December 17, 2002

Subject: Supplemental Response  
Pine County SWCD Wetland Comments  
Proposed Motor Sports Park  
Sandstone, Minnesota  
PEC Project No. 2002-052

**FIGURE 1**

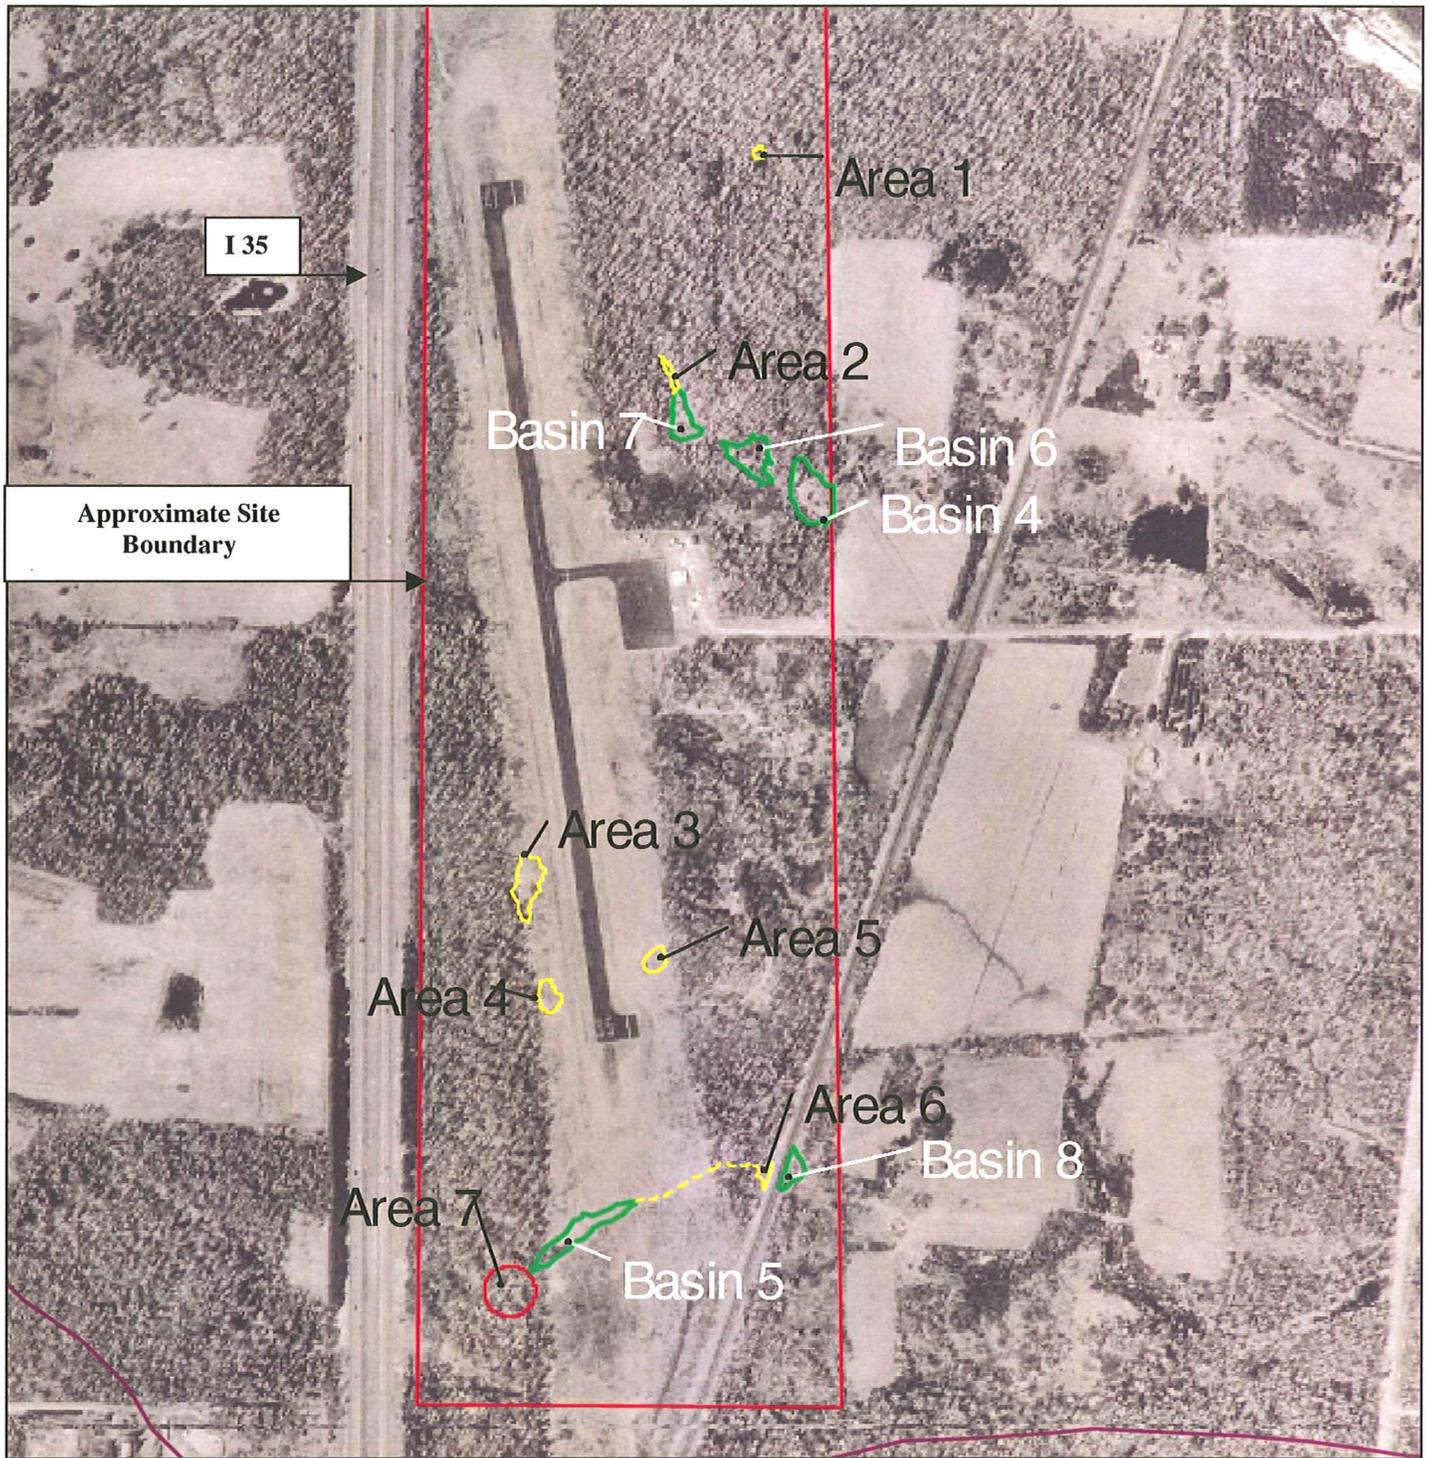
This letter is in response to wetland-related follow up comments regarding the proposed Sandstone Motor Sports Park that were submitted on December 12, 2002 by the Pine County SWCD. Peterson Environmental Consulting, Inc. (PEC) field reviewed all of these areas on December 14, 2002 and has prepared the following responses to the SWCD's follow up comments. **Figure 1** illustrates the respective locations of the wetlands delineated by PEC in August of 2002 and the areas being questioned by the SWCD.

The SWCD considered Area 1 an area of concern because it was a "forested depression". Upon further review PEC has identified an approximate 1,058 square foot (0.02 acre) temporarily inundated palustrine emergent wetland just east of the location cited by the SWCD. The size of this depression was determined using a global positioning system (GPS) unit rated at sub-meter accuracy. This very small depression is located in a very dense stand of aspen and was overlooked in the original delineation. The dark pattern circled on the aerial photograph by the SWCD is actually a small stand of pine trees. As shown in **Figure 2**, this basin is essentially a mudflat area that a few widely scattered clumps of tussock sedge (*Carex stricta*). Area 1 is far enough east that it would not be affected by grading activities for the proposed motor sports park.

We searched for Area 7 but could find nothing resembling a jurisdictional wetland in or around the location circled by the SWCD. We do not believe there are any jurisdictional wetlands anywhere in the vicinity of area identified by the SWCD. As this area is proposed for wetland mitigation, if there was a wetland in the vicinity it would incur no adverse impacts.

Approximately 4,881 square feet (0.11 acre) of additional jurisdictional wetland has been added in response to the SWCD's comments (i.e. Areas 1, 2 and 6). With one minor adjustment to the boundaries of the pro pit area, no portion of this 0.11-acre would be adversely affected by the proposed motor sports project.

An additional 23,788 square feet (0.55 acre) identified by the SWCD appears to be either non-wetland or artificially created incidental wetland (Areas 3, 4 and 5 combined; nothing resembling jurisdictional wetland was found in Area 7). If so, these areas would not be regulated under the WCA and no additional mitigation would be required. If all of these areas were to be treated as jurisdictional, the mitigation area would need to be enlarged by 23,788 square feet (0.55 acre). Ample space exists in the southwest corner of the site, should this be necessary.
